SERVICE BULLETIN No. 156

FENNER FLUID POWER Motor (Part # 15727) Drain Plugs Removal

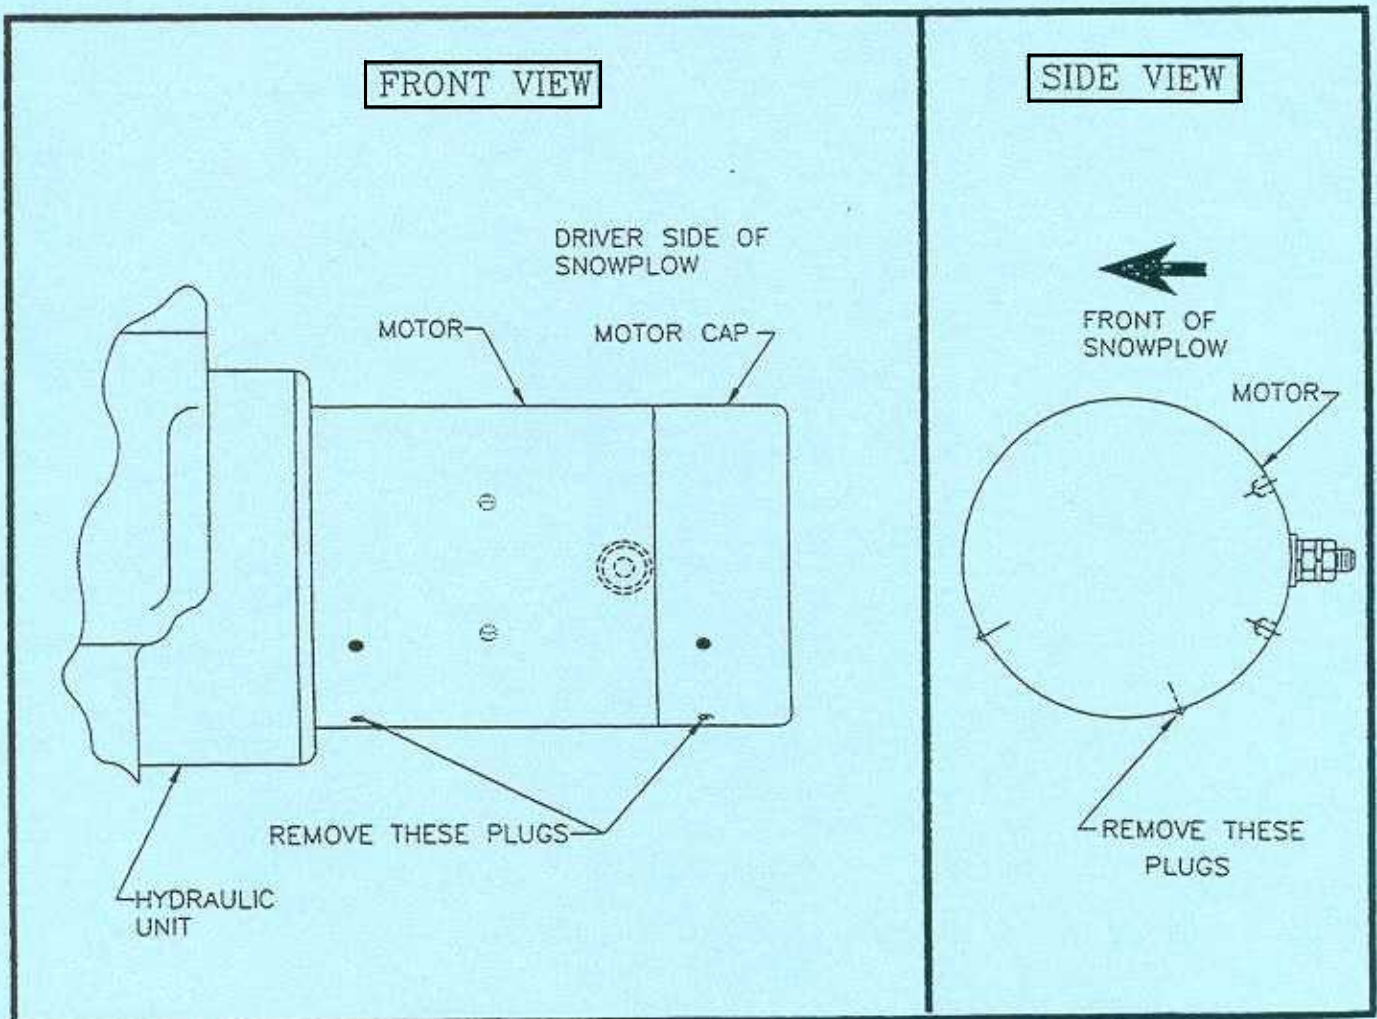
Fenner Fluid Power recommends removal of the plastic plugs from the motor end cover and motor housing as per illustration. Removal of these plastic plugs will prevent water/oil to collect within the motor housing. Removal of these plugs will also alert you to an oil leak, should a Pump Shaft Seal or Nylite washer fail beneath the motor.
